1. Minutes February 19, 2020 Regular Meeting. (March, April, and May meetings were canceled.)
- D. Action Items**
- 5:45 2. Certificate of Appropriateness Application**
BAR 20-03-01 (previously noted as BAR 19-09-03)
503 Rugby Road
Tax Parcel 050052000
Epsilon Sigma House Corps of Kappa Kappa Gamma, Owner
Erin Hannegan (Mitchell Matthews Architects), Applicant
Building renovations – revisions to approved design

ATTACHMENT A: FEBRUARY 19, 2020 BAR MEETING MINUTES

**BAR MINUTES
CITY OF CHARLOTTESVILLE
BOARD OF ARCHITECTURAL REVIEW
Regular Meeting
February 19, 2020 – 5:30 p.m.
City Council Chambers - City Hall**

- Mitchell Matthews Architects & Planners drawings 503 Rugby Road, Kapp Kappa Gamma Sorority, Board of Architectural Review: CoA Submission Amendment, dated February 25, 2020: Cover and sheets 2 through 37.

EXTERIOR LIGHTING

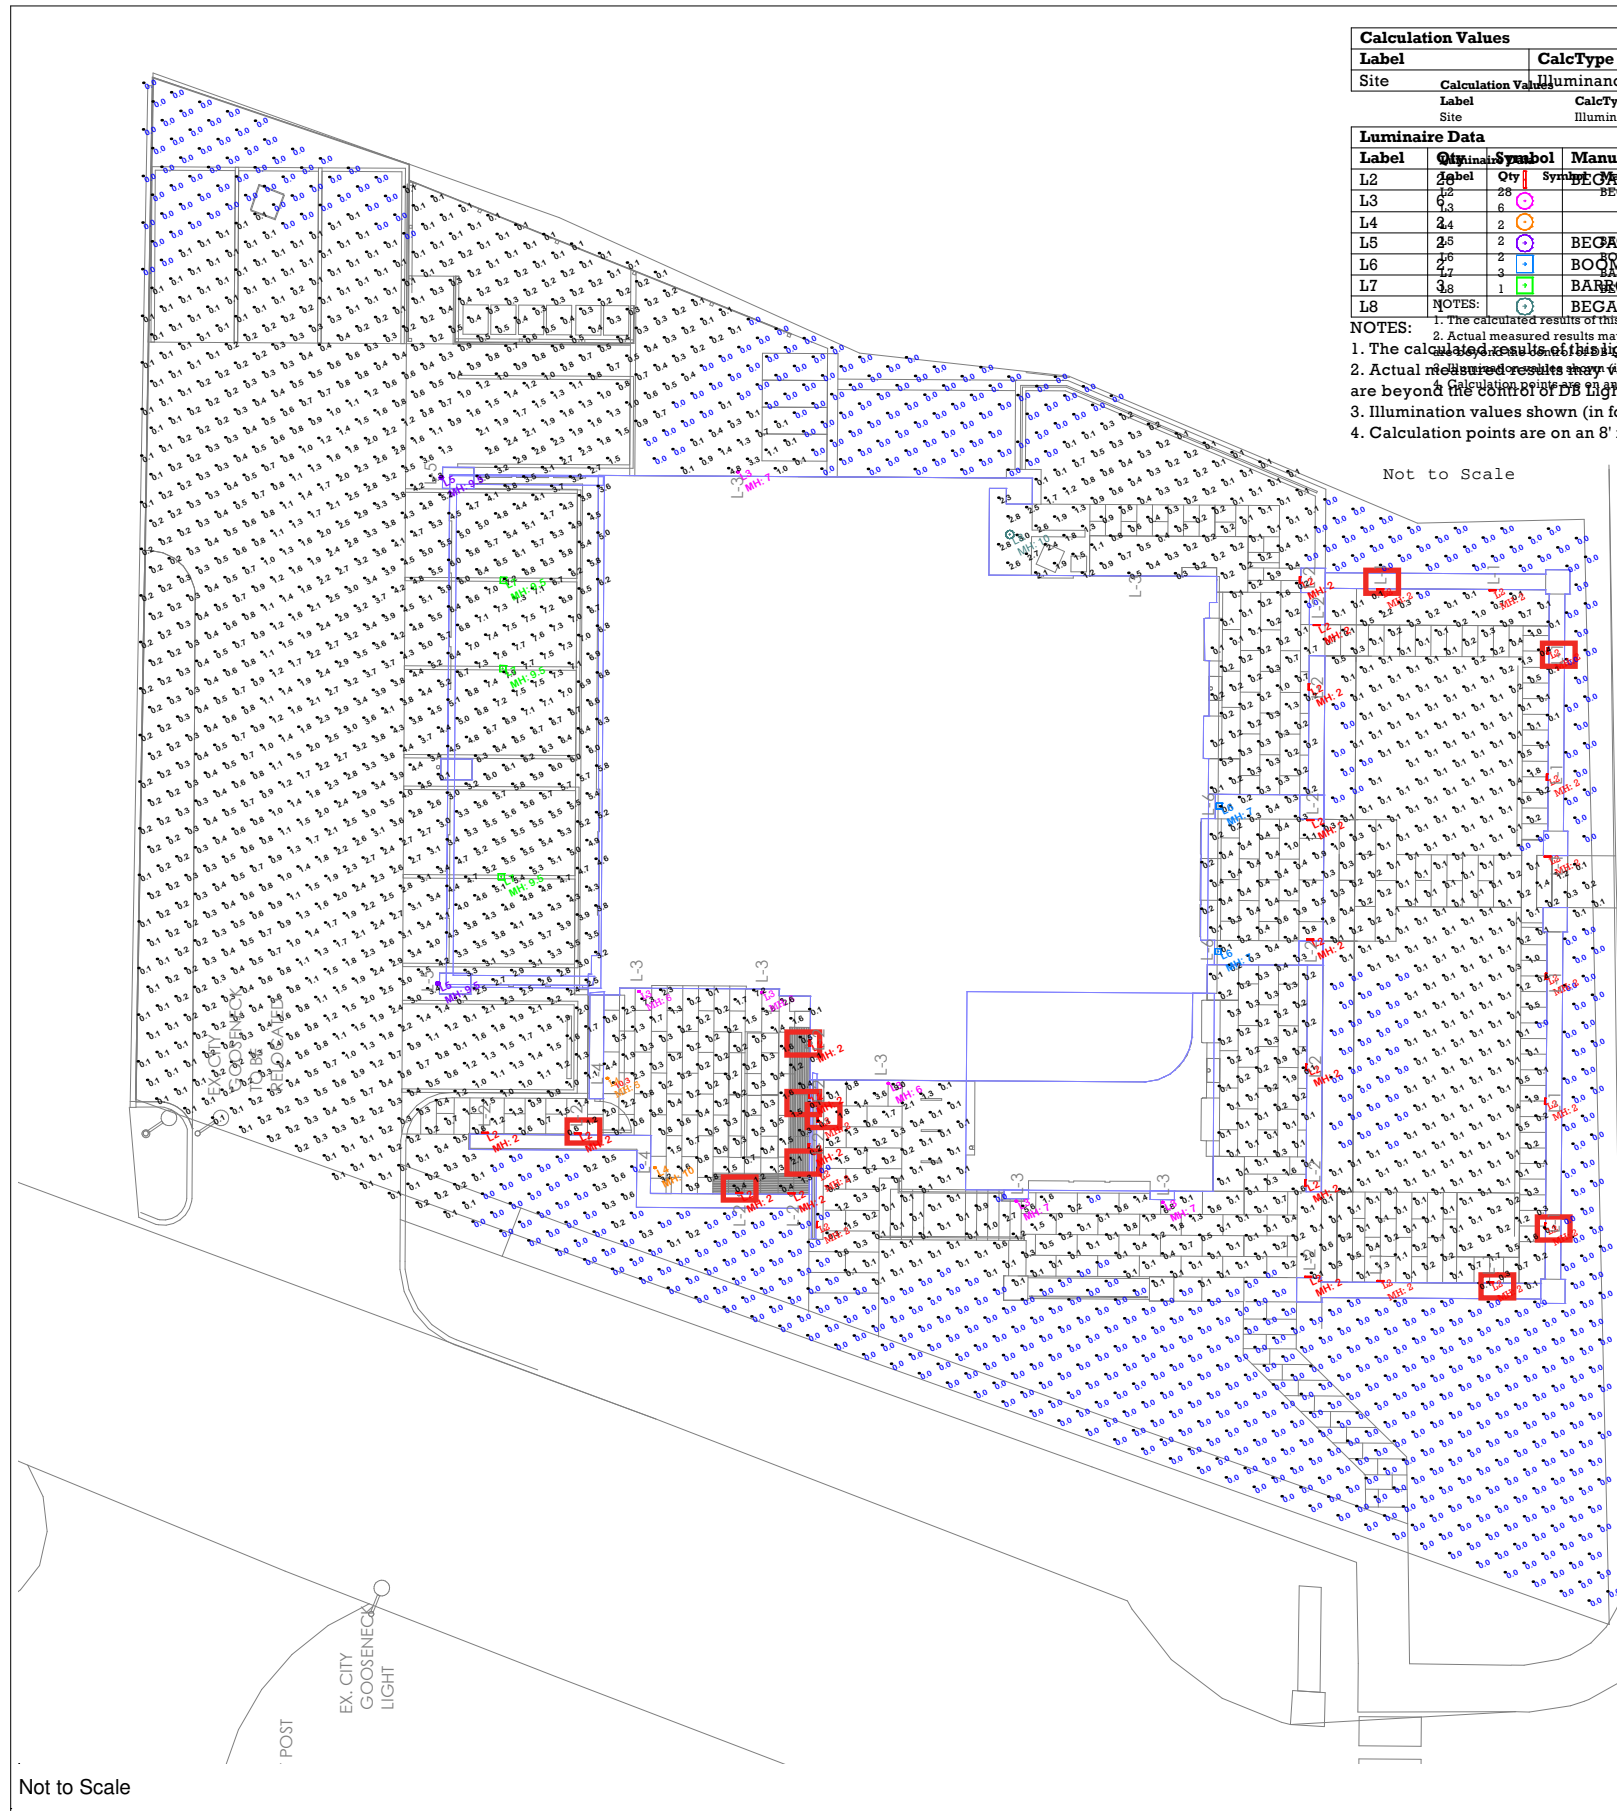
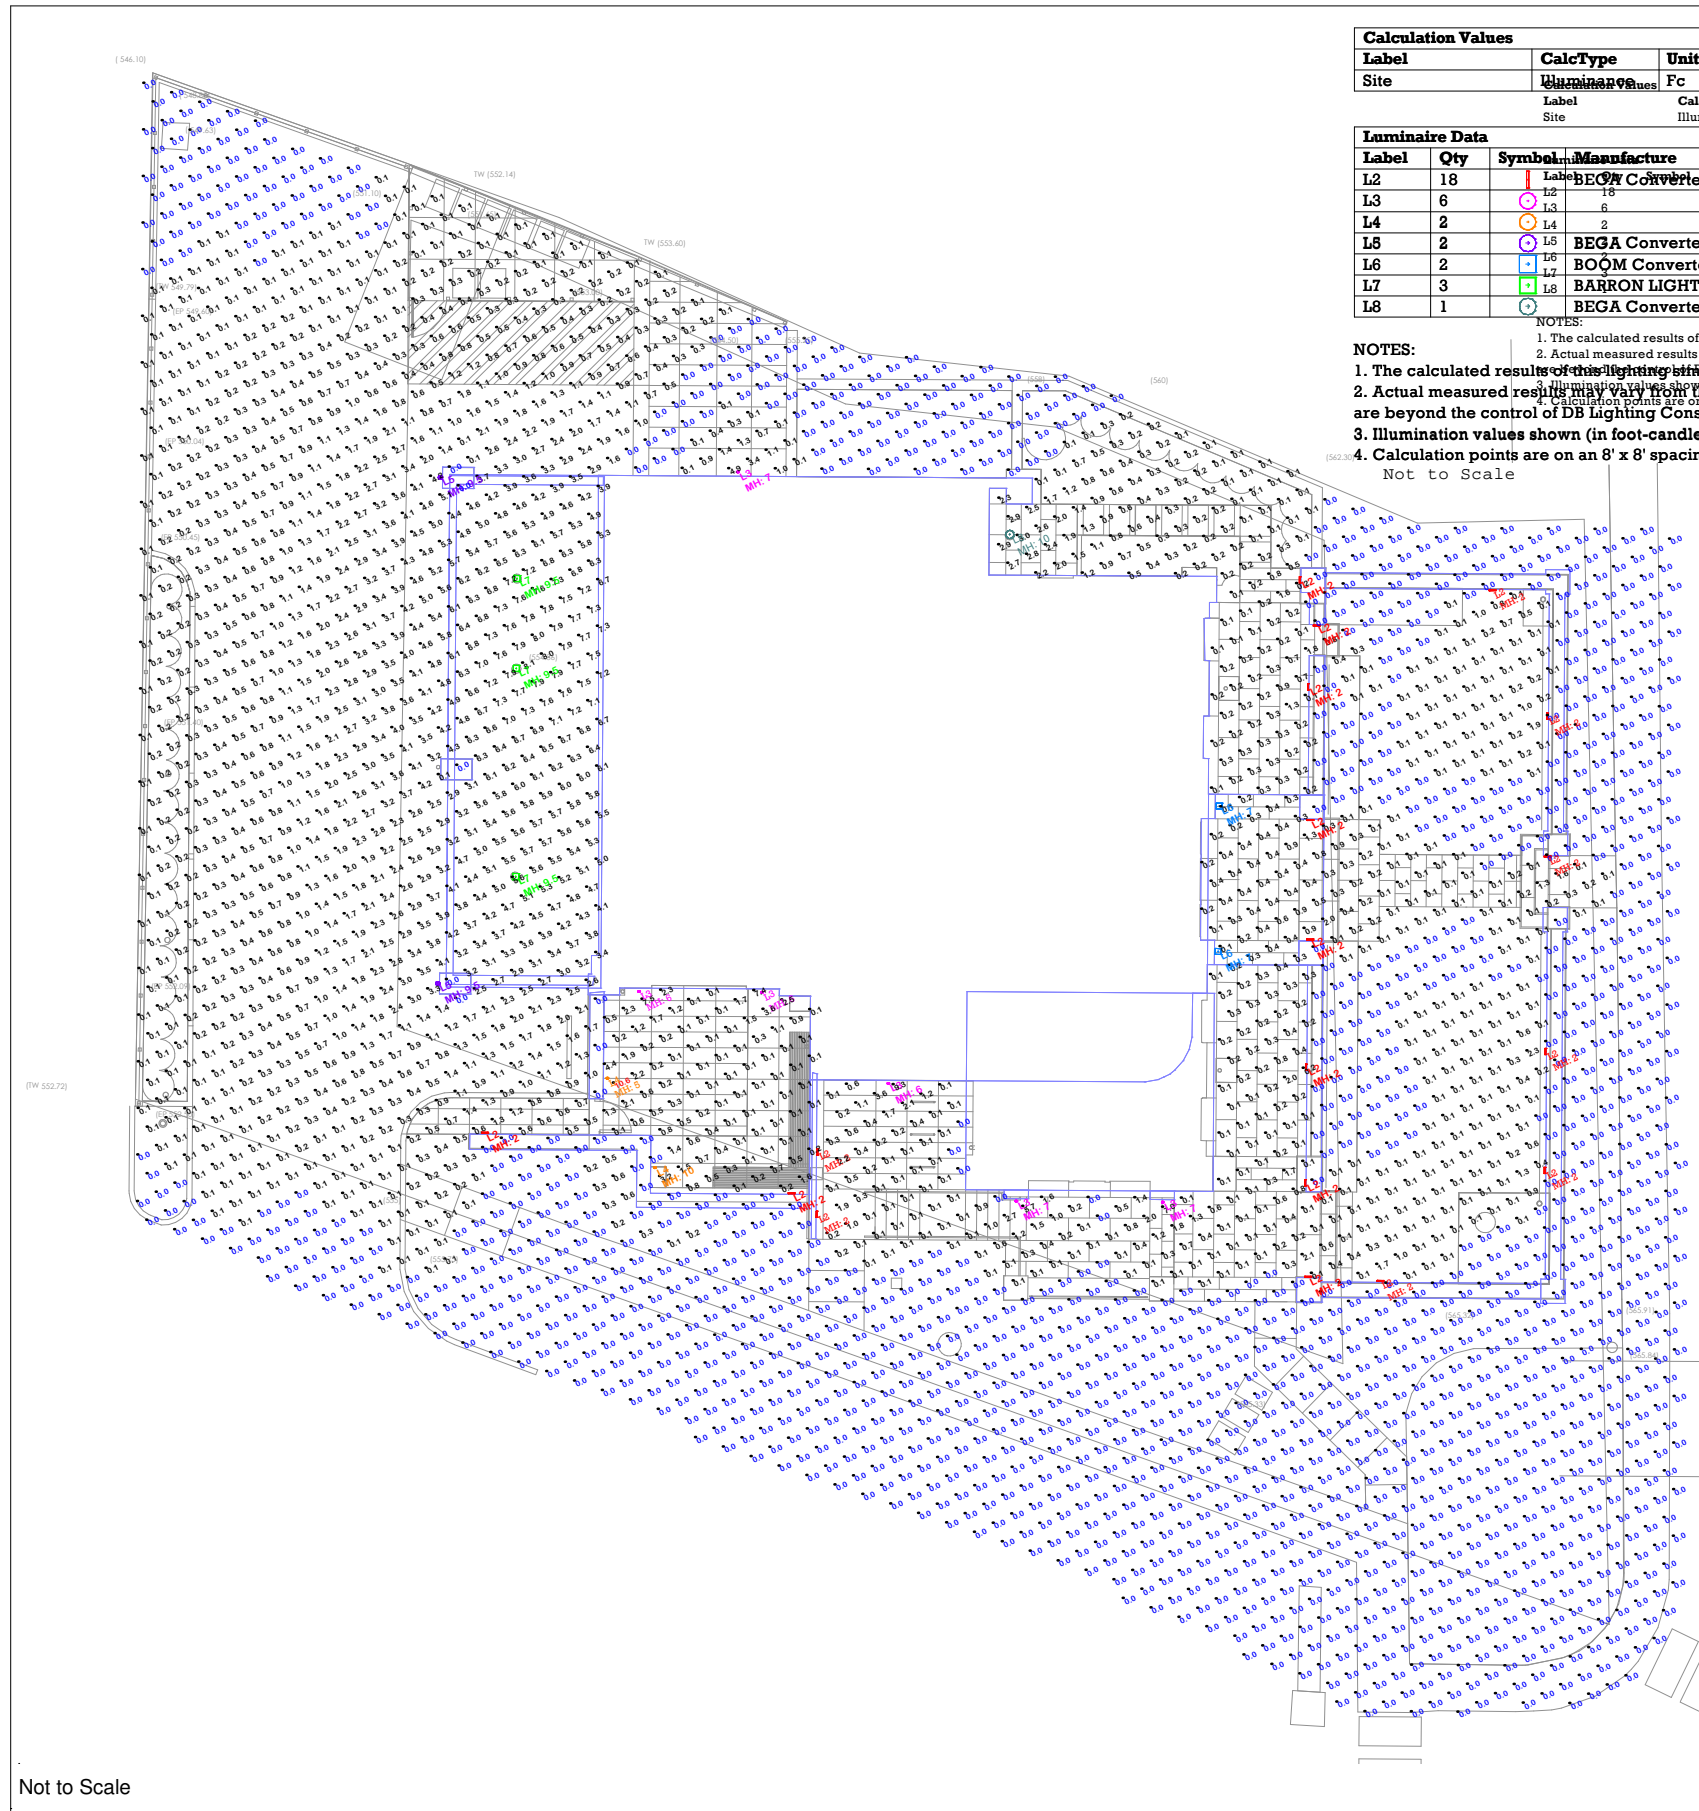
- Staff: Reduction of lighting is consistent with the Design Guidelines.
- Delete the pergola over the lower side terrace.
 - Staff: No issues.
- Delete/defer pergola over Kappa beach. Proposed as an add alternate to retain.*

REDUCTION IN THE QUANTITY OF L2 FIXUTRES
ONLY(REMOVAL OF 10), RESULTING IN CHANGES
TO THE PHOTOMETRIC LIGHTING PLAN
